SAFETY RECALL CODE 0812 - 1999 X1 REAR BRAKE LINE AND POSITIVE BATTERY CABLE

This campaign involves all 1999 X1 model Buell motorcycles manufactured between January 4, 1998 and April 20, 1999.

B-020

Figure 1. Rear Brake Line - Right Side

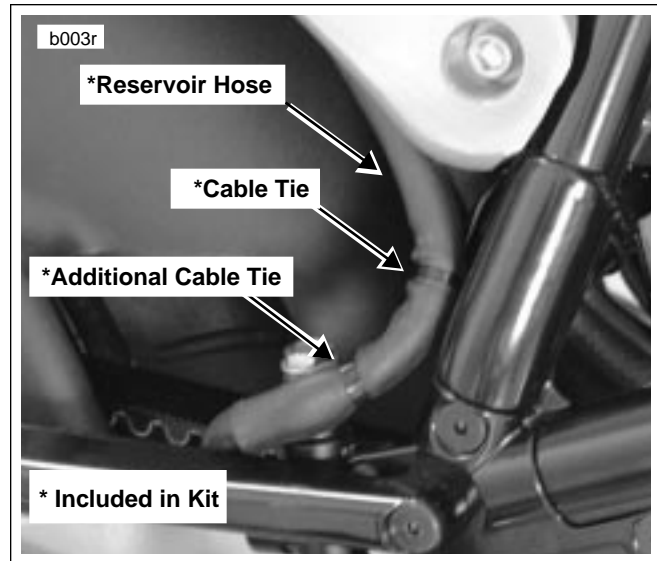
7. See Figure 1. Cut cable tie holding rear brake reservoir hose to rear brake line above rear master cylinder on right side of motorcycle.
8. See Figure 4. Disconnect two wires from rear brake light switch.
9. Remove rear master cylinder banjo bolt and two banjo washers. Discard banjo washers.
10. Remove rear brake caliper banjo bolt and two banjo washers. Discard banjo washers.
11. Carefully push up on bottom of oil tank to allow rear brake line tangs to be freed from studs on the bottom of the oil tank.
12. See Figure 2. Cut cable tie on wiring harness and cable tie on vent tube on left side of bike.
13. Slide rear brake line into area where battery usually sits and then off of bike through left side of frame.
14. See Figure 4. Remove rear brake light switch from original brake line.

22. See Figure 1. Inspect rear brake reservoir hose on right side of motorcycle for damage. Replace as required by installing **new** replacement hose provided in kit. If hose is undamaged, proceed to step 23.

23. See Figure 1. Install two cable ties (thick) to reservoir hose and rear brake line in **two** locations as shown in figure. Use care to avoid pinching hose.

Figure 2. Rear Brake Line - Left Side

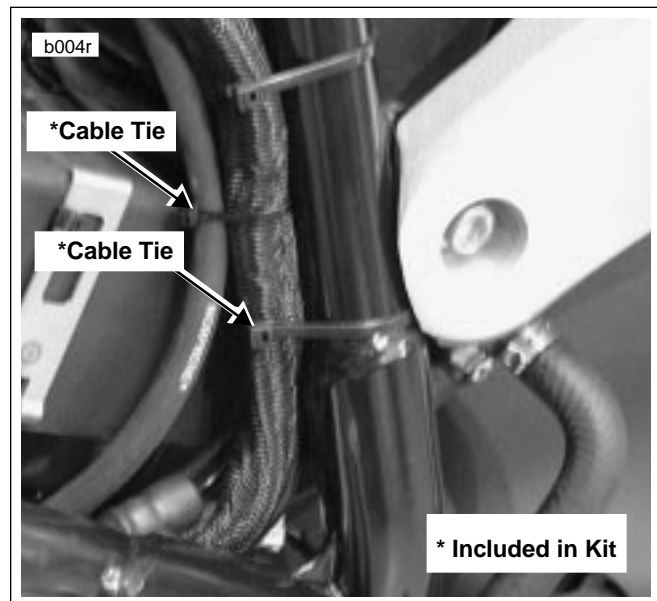
25. See Figure 6. Inspect positive battery cable and vent lines (transmission vent and cam cover vent) for damage. Replace as required.
26. See Figure 2. Cable tie vent hose and wire harness to frame on left side of motorcycle. NOTE: Use thick cable tie on wire harness and thin cable tie on vent hose. Use care to avoid pinching hose.

Figure 3. Loop Clamp Orientation Before Installation

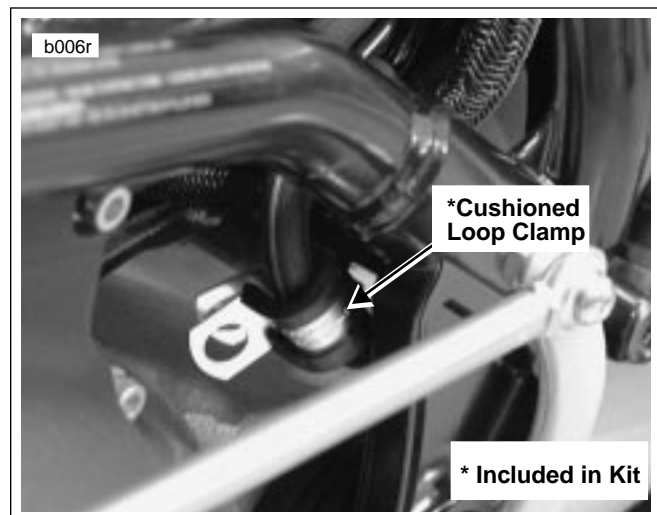
19. See Figure 3. Install loop cushioned clamp provided in kit to brake line and then to bolt side of tie bar fasteners. Loop clamp is oriented down and to the left. Install tie bar to frame with bolt, washer and loop cushioned clamp on lower side of tie bar and **new** locknut on upper side of tie bar. Tighten to 30-33 ft-lbs (40.7-44.7 Nm).

Figure 4. Rear Brake Light Switch

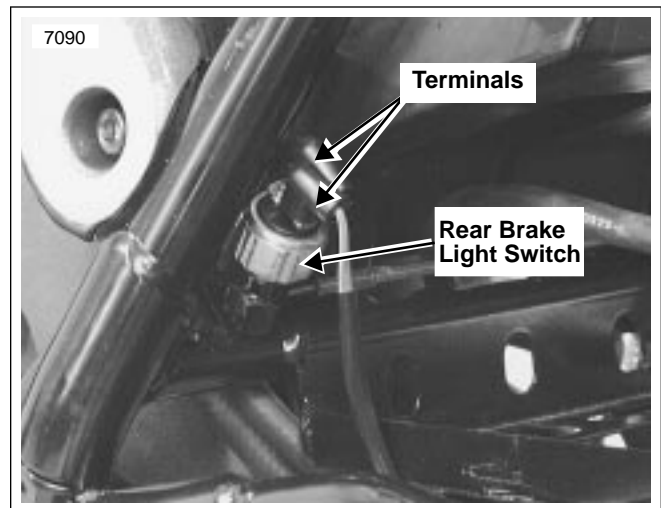
15. Coat threads of rear brake lamp switch with LOCTITE PIPE SEALANT WITH TEFLON and install to **new** brake line. Tighten switch to 84-96 **in-lbs** (9.5-10.8 Nm). Tighten as required to orient terminals perpendicular to brake line.

34. Attach oxygen sensor connector to battery strap with **new** thin cable tie on left hand side of motorcycle.
35. See Figure 4. Connect rear brake light switch wires to rear brake light switch.

Figure 5. Rear Brake Line Routing

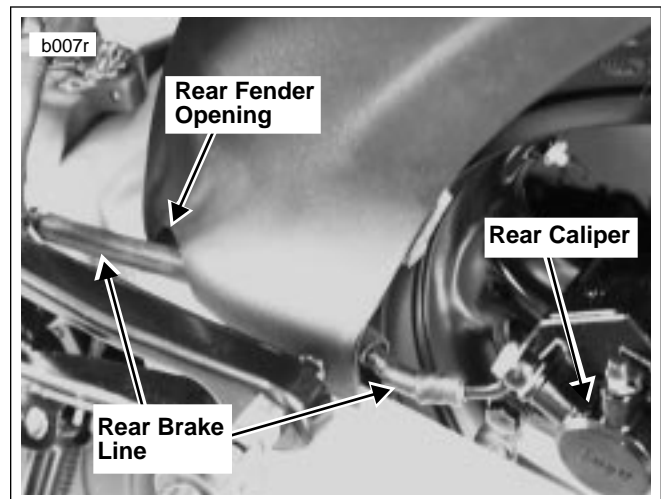
17. See Figure 5. Working from the right side, install **new** brake line and align metal portion of brake line with rear master cylinder. Route caliper side of brake line in front of tie bar and through rear fender opening to rear caliper.

Figure 6. Positive Battery Cable Routing

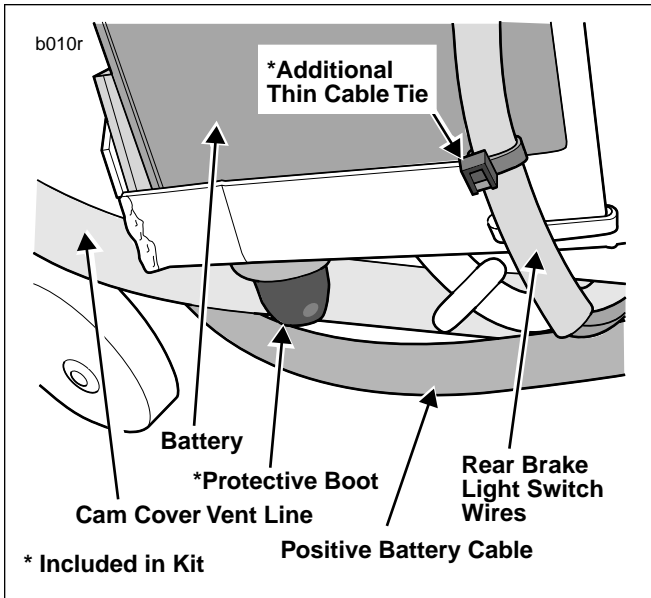
27. Cut cable tie on frame cross member behind battery tray that secures cam cover vent and transmission vent.
28. See Figure 6. Attach cam cover vent (thinner of two vent lines) to frame cross member in original location with **new** (thick) cable tie. Make sure cam cover vent line is routed inboard of stud and nut on bottom of battery tray.

30. See Figure 7. Attach transmission vent line to oil return line as shown with **new** (thick) cable tie.
31. See Figure 6. Reroute positive battery cable from starter solenoid post **under** rear brake light switch wires and **under** cam cover vent line then behind and over battery to positive terminal.

32. See Figure 6. Install protective boot, included in kit, over stud and nut on bottom of battery tray on right hand side of motorcycle.
33. Install battery with strap and nut. Tighten nut to 40 **in-lbs** (4.5 Nm).

36. See Figure 6. Attach rear brake light switch wires to battery strap with **new** thin cable tie on right hand side of motorcycle. NOTE: HDI (all except Canada, Japan and New Zealand) models do not require this cable tie as the brake light switch wire routing is different.

Figure 7. Transmission Vent Line Routing (Rear View)

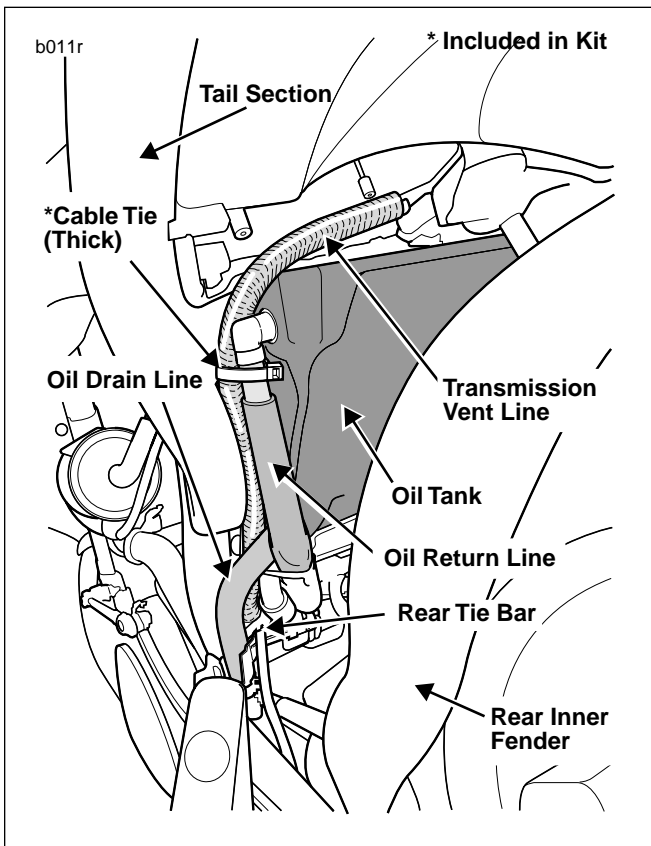
29. See Figure 7. Reroute transmission vent line to **left** side of motorcycle, **under** battery tray, **over** rear tie bar, **above** rear brake line, **between** oil drain line and tail section, **above** oil return fitting (on oil tank), and **over** the top of the oil tank. Use care to avoid kinking hose after tie bar.
